<b>Date Issued:</b>	4/13/2016	<b>Effective Date:</b>	
<b>Project:</b>	WTP Modifications	<b>Contract No.:</b>	2015-0062

<b>Owner:</b>	City of Franklin	<b>Owner's Project No.:</b>	2015-0062
<b>Engineer:</b>	Smith Seckman Reid, Inc.	<b>SSR Project No.:</b>	12-41-013.0
<b>Contractor:</b>	Judy Construction Co.	<b>Government Project No.:</b>	N/A

Owner Contract No.	<b>2015-0062</b>
Project Name:	<b>Franklin Water Treatment Plant Modifications</b>
Engineer:	<b>Smith Seckman Reid, Inc.</b>
Contractor:	<b>Judy Construction Company</b>

① UPPER LEVEL - MECHANICAL DUCTWORK PARTIAL PLAN  
 1" = 10'-0"

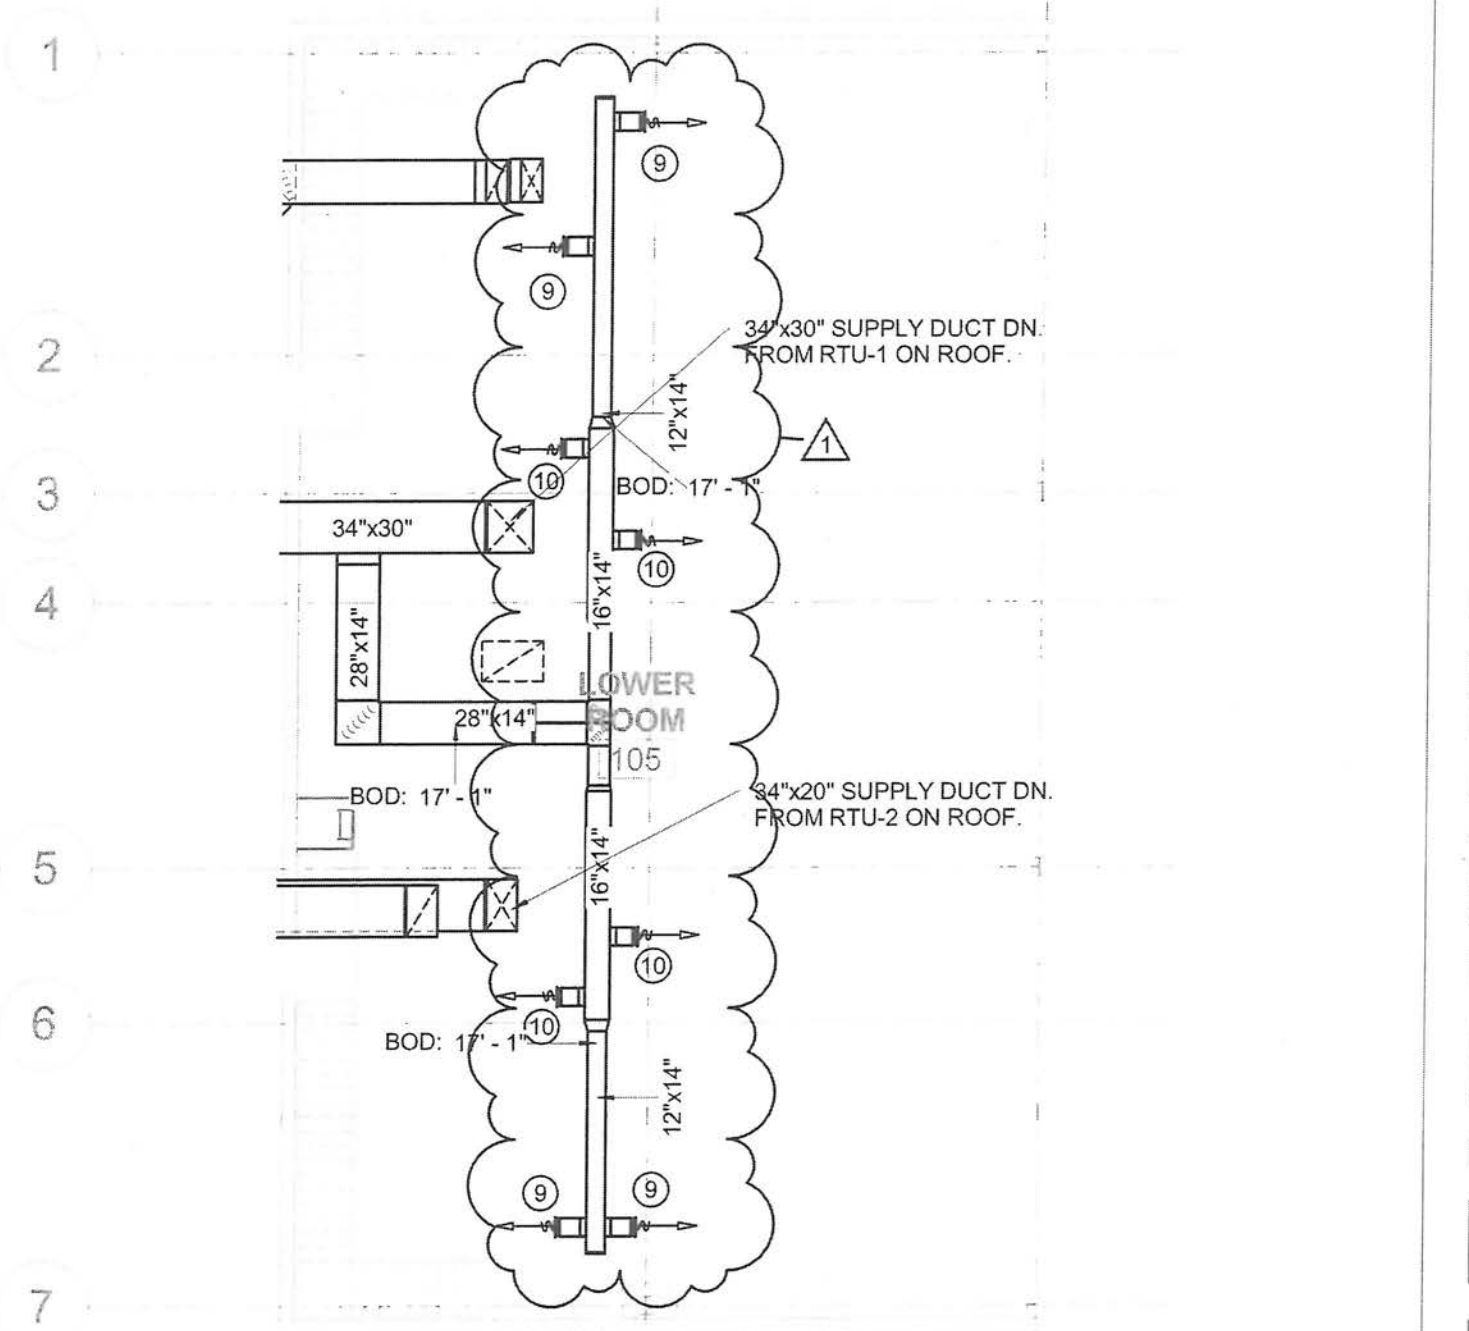
Owner Contract No.	<b>2015-0062</b>		
Project Name:	<b>Franklin Water Treatment Plant Modifications</b>		
Engineer:	<b>Smith Seckman Reid, Inc.</b>		
Contractor:	<b>Judy Construction Company</b>		
<b>DESCRIPTION OF CHANGE</b>			
Duct relocation in GAC Room, Rm. 105. Ducts moved to avoid conflict with height of GAC tanks. See attached Sketch SKM-1 for details.			
(Attach Supporting Documentation)			
Requested By:	<b>ENGINEER</b>		
This Document is a:	<b>FIELD ORDER (FO)</b>
